# BLOCK 56S - TOWER

401 8TH AVE N. RECOMMENDATION MEETING - ADR | DATE: NOVEMBER 20, 2020 | SDCI #3017379

ANKROM MOISAN ARCHITECTS // SITE WORKSHOP // VULCAN REAL ESTATE

Tower Position and Shadows

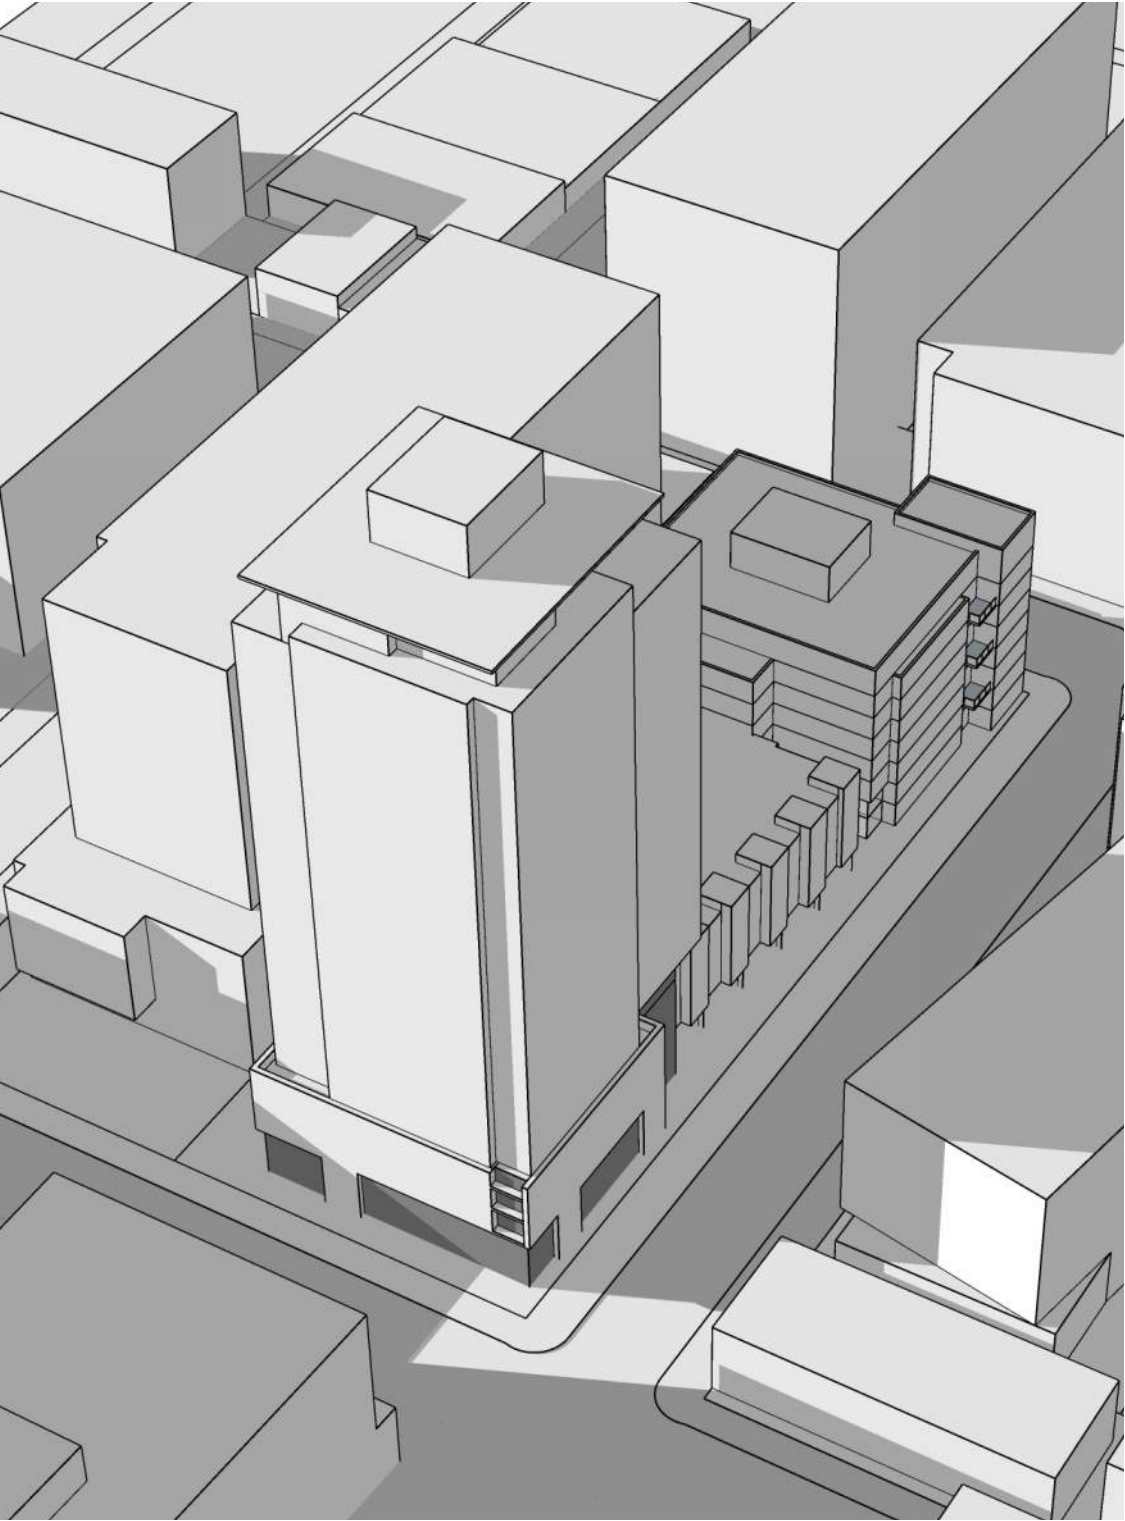
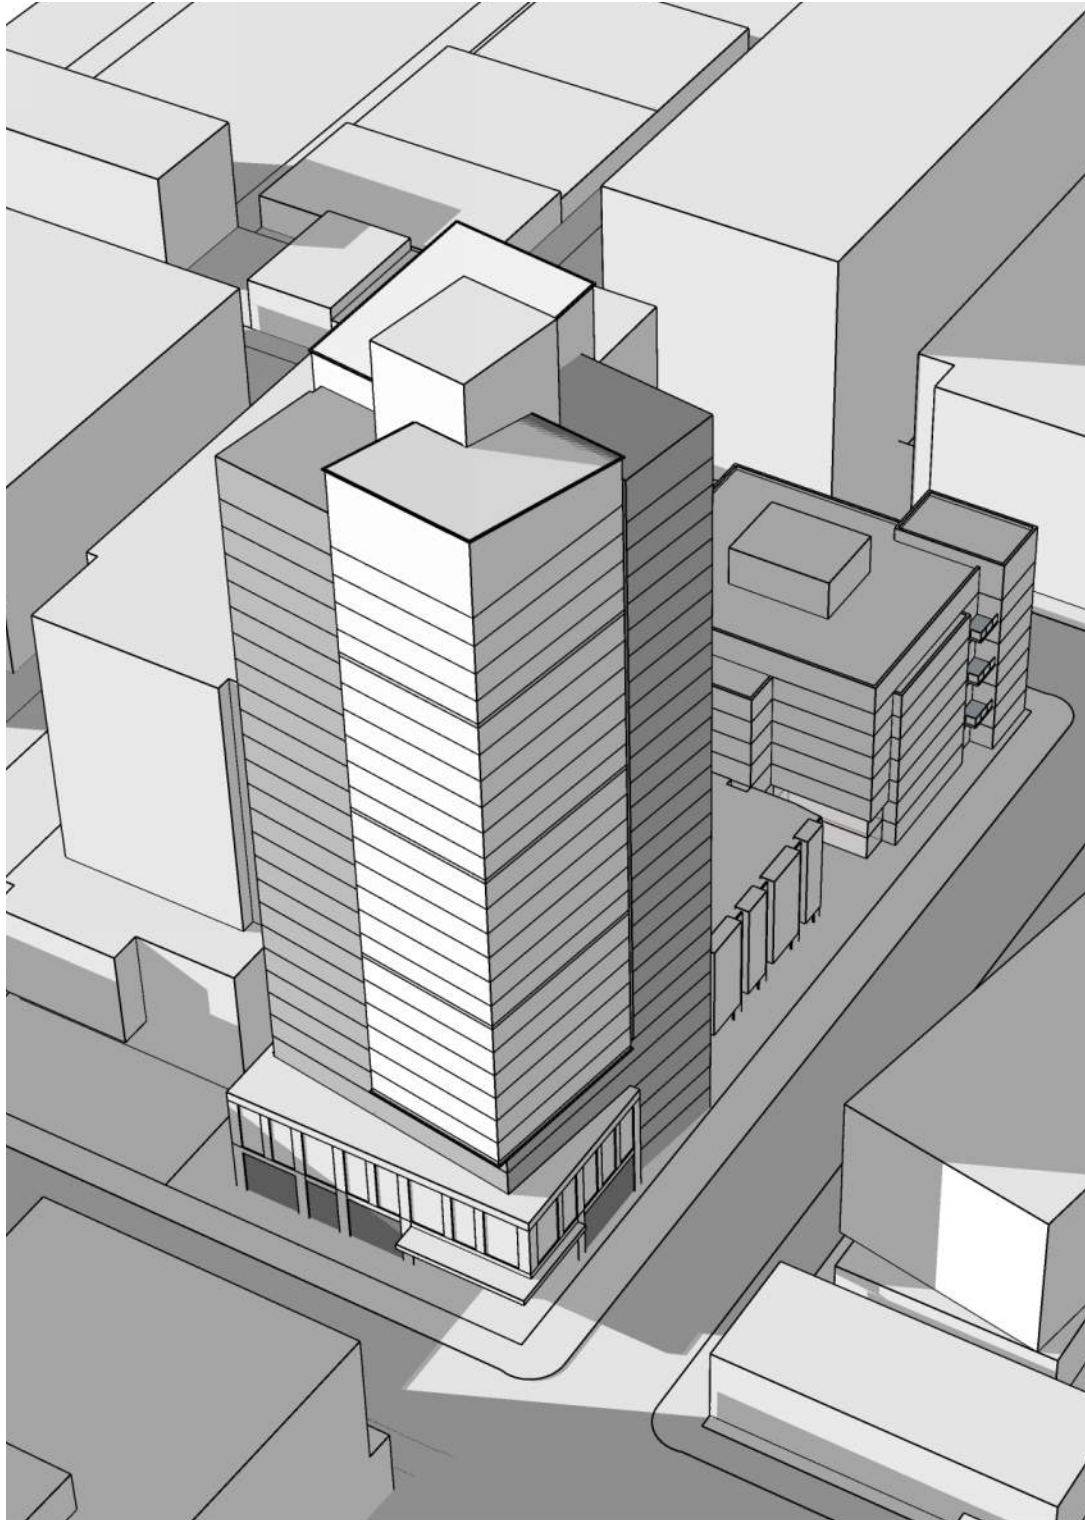
The Board basically endorsed massing option C with the tower on the south of the site, recognizing that shadows from a tower in either position would equally shade the 8th Avenue 'room' formed by the approved MUP design on the east side of the block. However, there were critical qualifiers to the massing outlined below.

The design team has advanced the design with the tower placed on the south end of the site, as supported by EDG option C. This tower placement minimizes the overlap with now constructed 400 Dexter office building to the west of the alley, providing maximum privacy to and from it. The 8th Avenue 'room' that is formed by now constructed 8th+Republican project is mostly shaded by 400 Dexter project.

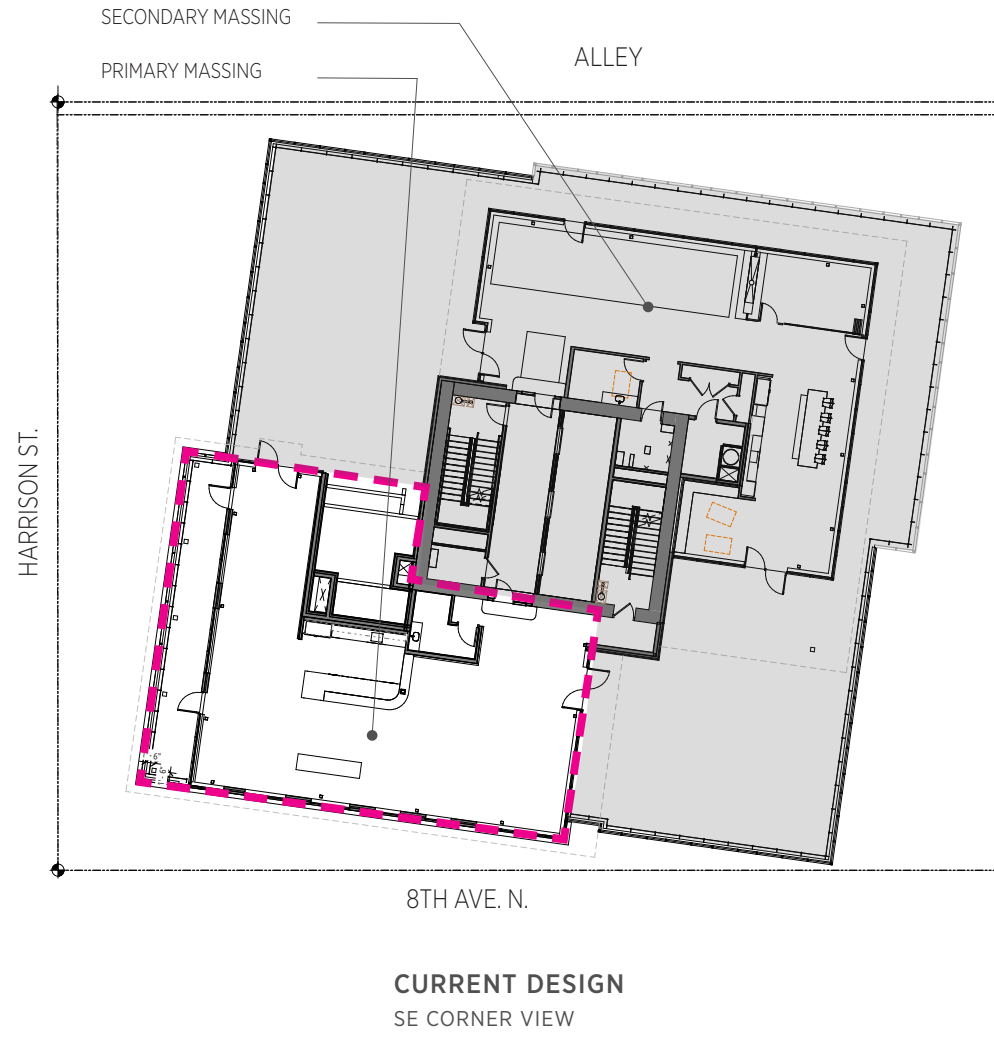
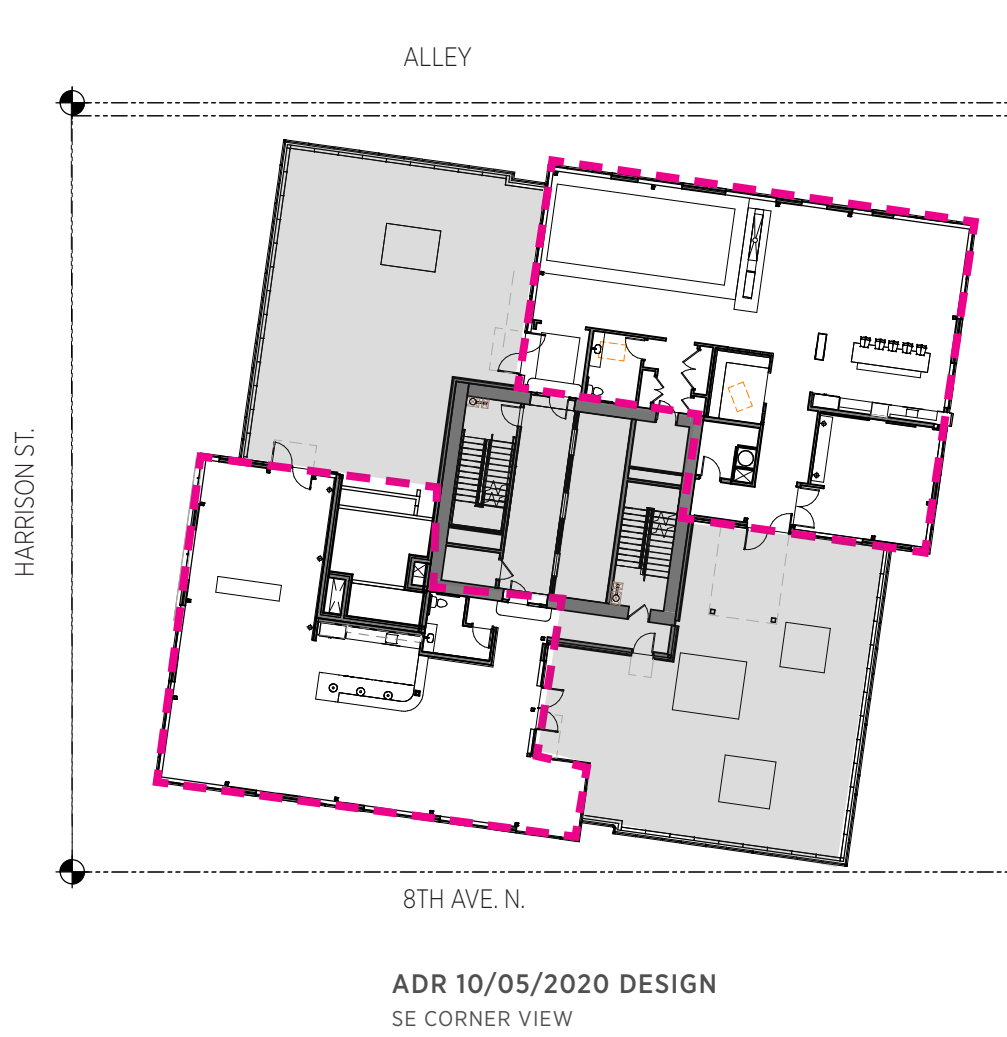
The two projecting tower elements are nearly identical in size, height and expression but their 'situation's are very different:

- a. One is at the corner of two streets: 8th Avenue and Harrison Street, with south and east exposure.
- b. The other is at the intersection of the alley and a shared property line with north and west exposures.

The project team has modified the design to distinguish the street corner at SE and the interior property corner at NW. The team has eliminated the light massing at NW corner and made it to be part of the dark massing. In order to do so, the team had pushed the NW top down to align with the parapets, pulled the massing all the way down to the top of podium to align vertically, pushed NW amenity space away from the edge, and removed the notch on west facade.

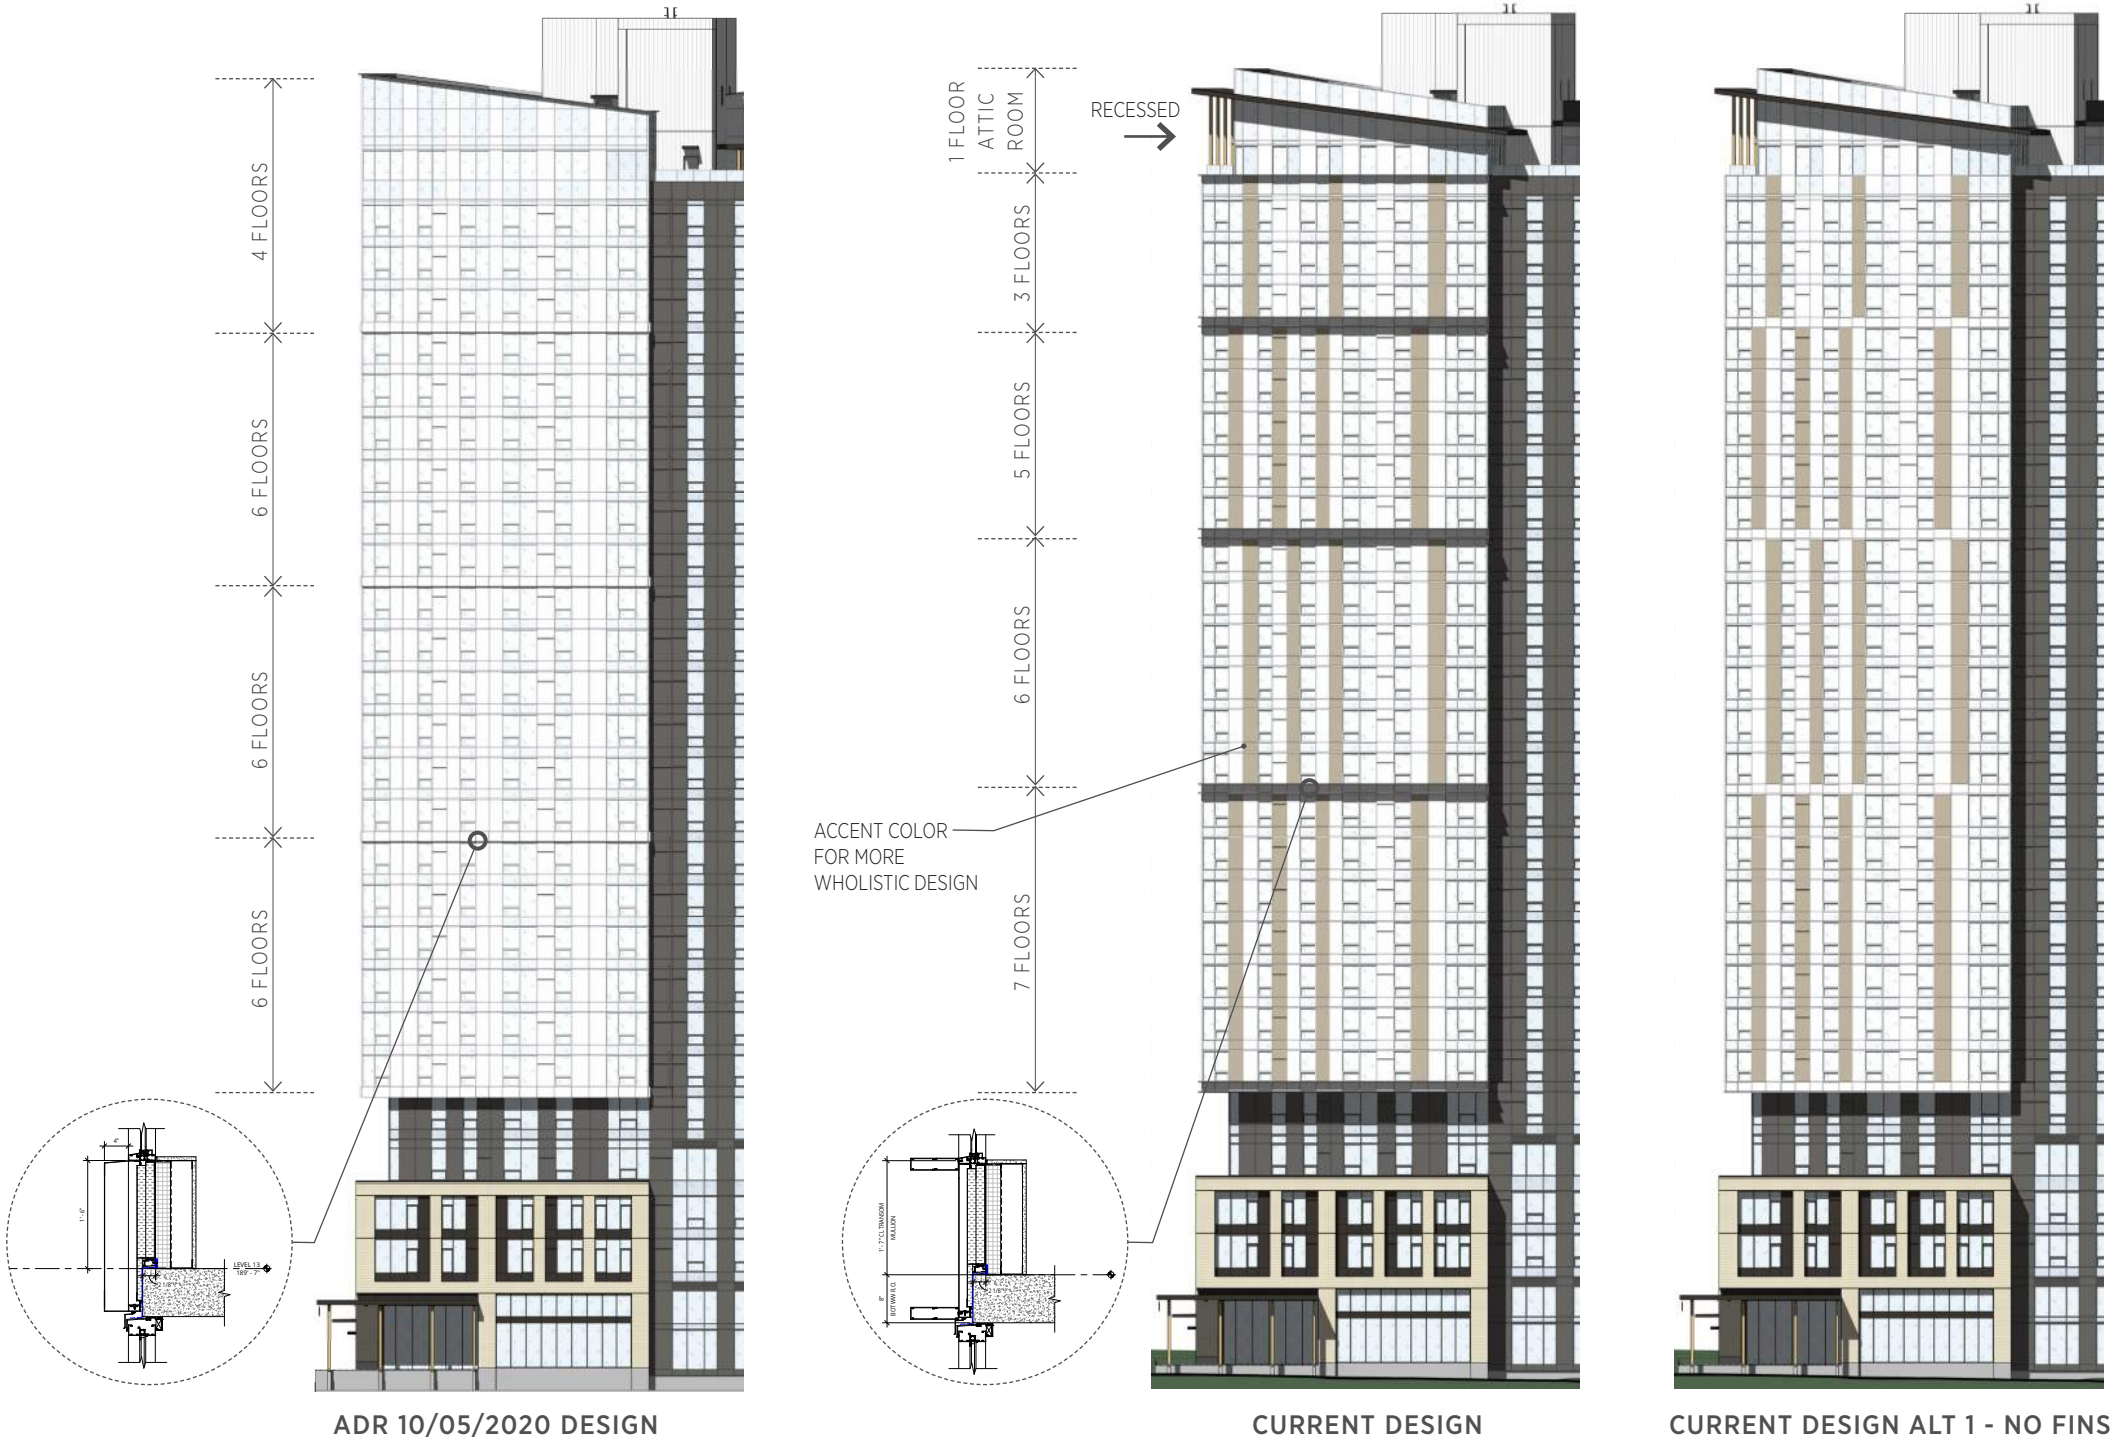
The graphic (rather than architectural) expression of those projecting tower elements as four very similarly scaled blocks.

The project team has studied and revised the floor groupings to 5 variously scaled blocks. The floor grouping starts large, and gets smaller as it moves up, until it reaches the "attic" scale at the top. The detail at the floor groupings have been revised from 4" raised panels to double- 8" horizontal fins to create stronger shadow lines. At the top "attic" block, the facade is recessed to create a massing modulation, and in turn, creates strong shadow line and visual intrest at the top.

Per the additional email comment provided by the staff on 10/22/2020, the project team has also provided an alternate scheme which eliminates the horizontal fins altogether.
